From: [Victoria Lane \(Brodies Solicitors\)](#)
To: [Hornsea Project Three](#)
Cc: [Karen Hamilton \(Brodies Solicitors\)](#)
Subject: Spirit Energy ISH 1 Submission - Appendices List and Appendix ZD - ZO [BRO-D.FID4510105]
Date: 14 December 2018 23:26:32
Attachments: [image002.png](#)
[image004.png](#)
[image006.png](#)
[image008.png](#)
[image010.png](#)
[image012.png](#)
[SE ISH 1 - Appendix ZN - Comprehensive analysis of flying conditions \(percentage frequency outcome\) based on 3-hourly weather data for J6A \(1 October 2017 - 29 September 2018\) 44088947_1.PDF](#)
[SE ISH 1 - Appendix ZM - Expert assessment of flying conditions for ARA - Sample of weather forecasts at Block J-West \(1 October 2017 - 29 September 2018\) 44088940_1.PDF](#)
[SE ISH 1 - Appendices List - 14 December 2018 44089241_1.PDF](#)
[SE ISH 1 - Appendix ZO - Issue Specific Hearing 1 \(4 December 2018\) - Summary of Evidence 44089235_1.PDF](#)

ADDENDUM TO AVIATEQ INTERNATIONAL LIMITED REPORT (DECEMBER 2018)

Proposed Hornsea Three Offshore Wind Farm Addendum

Orsted Annex 8.1: Figure 7.4
Indicative Instrument Approach Procedure as Existing (without Turbines Present)

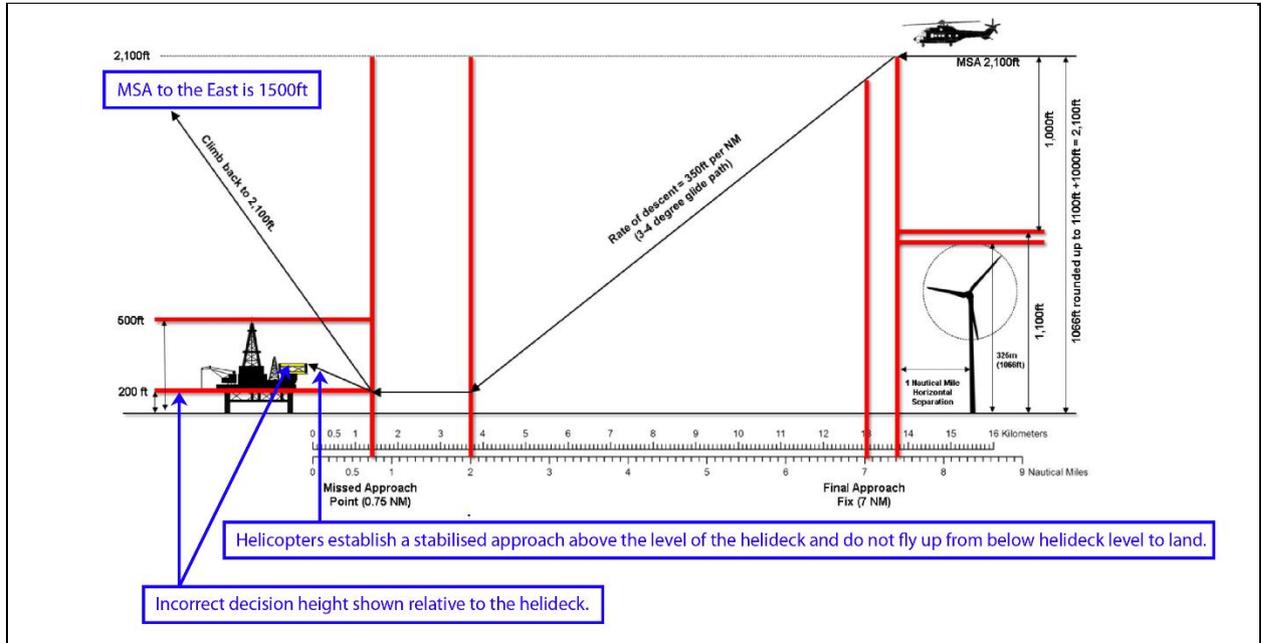
8.1 The diagrams, Figures Nos. 7.4 (page 22) and 7.5 (page 23) in the Environmental Statement: Volume 5, Annex 8.1 Aviation (PINS Reference A6.5.8.1) (May 2018) are in fact not correct, because they show that the MDH is 200ft which is below the height of the helideck shown on the diagrams. The Minimum Descent Height (MDH) when carrying out an ARA during the day is 200ft or 50ft above the helideck height, whichever is the higher. ARAs conducted at night require an MDH of 300ft or 50ft above the helideck height, whichever is the higher. This is addressed in paragraph 3.31(2) of CAP 764 which states:

Orsted Annex 8.1: Figure 7.5
Indicative Instrument Approach Procedure as Proposed (with Turbines Present)

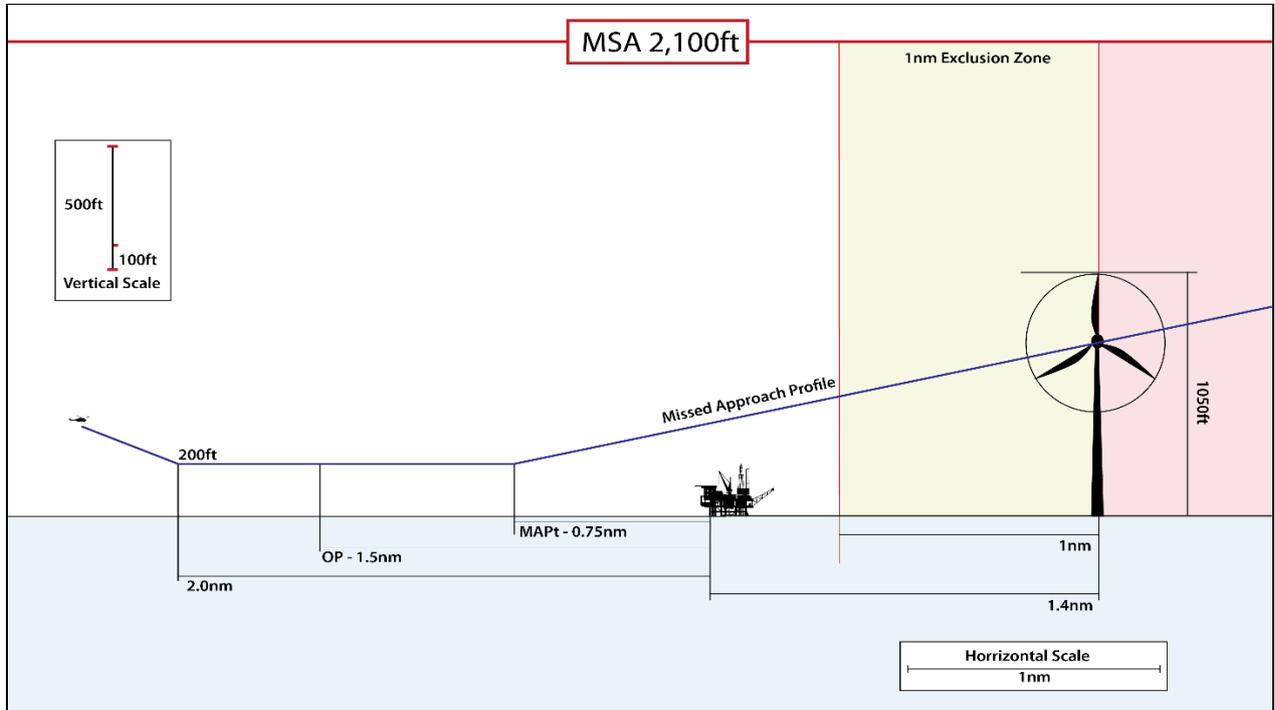
8.2 Furthermore, diagram Figure No. 7.5 in the same Environmental Statement: Volume 5, Annex 8.1, does not show the correct climb profile in the event of a missed approach. The diagram shows a helicopter approaching from over the windfarm at the MSA of 2100ft. A missed approach from this direction would be away from the windfarm and require a climb to 1500ft, which would be the MSA in that sector.
